Subject: Neighborhoods of Willow Creek and Hidden Canyon (Key Site 21) Project, Final Subsequent Environmental Impact Report (SCH #2018031077) Revision Letter Project Case No. 19EIR-00000-00002

Neighborhoods of Willow Creek and Hidden Canyon
(Key Site 21) Project
Final Subsequent Environmental Impact Report
Revision Letter

SCH #2018031077
Project Case No. 19EIR-00000-00002

Figure 1 Willow Creek Tract Map Modification Exhibit

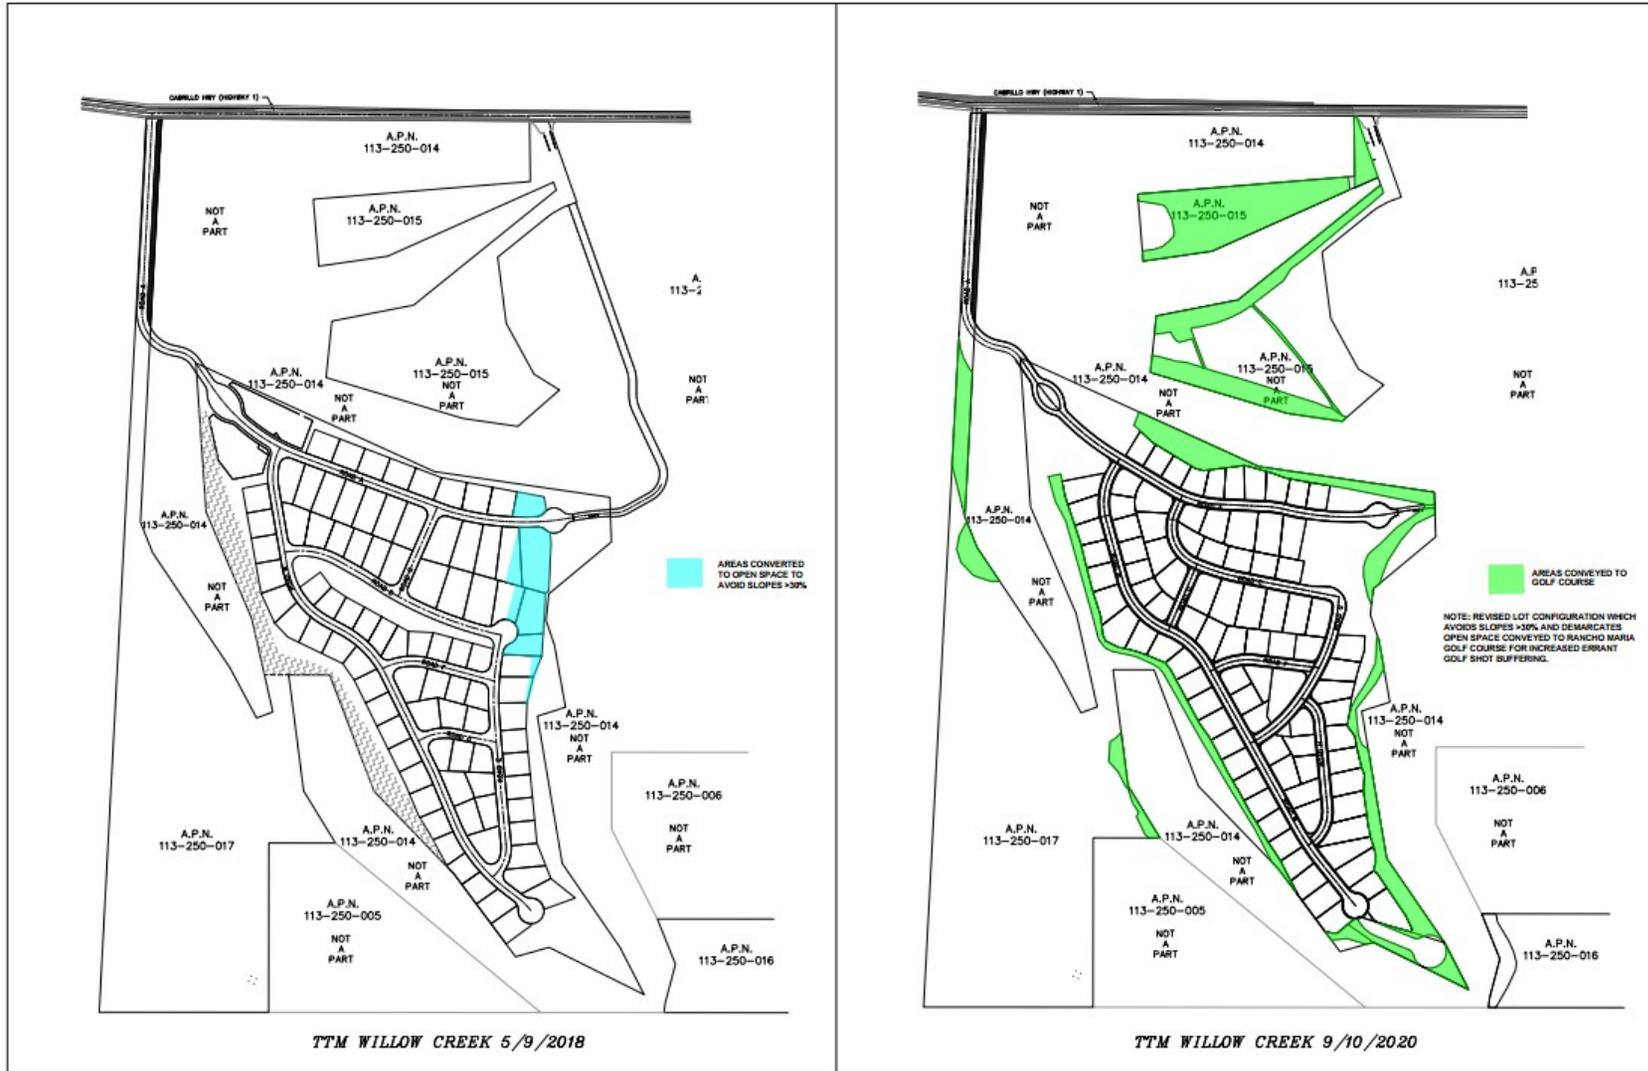
The proposed modification to the Neighborhoods of Willow Creek and Hidden Canyon (Key Site 21) Project is a revision to the proposed VTTMs to avoid residential lots on slopes exceeding 30 percent. This change is intended to ensure consistency with the Orcutt Community Plan Development Standard GEO-O-2.2, which limits development on steep, unstable, and highly-erosive slopes:

This modification to the project would reduce the number of new residential units from 146 single-family residences to 143 single-family residences (a reduction of two residential lots in the proposed Hidden Canyon neighborhood and one residential lot in the proposed Willow Creek neighborhood), and would reduce the number of lots in the proposed VTTMs from 148 to 145 lots. The reduction in residential lots would also reduce the overall development footprint
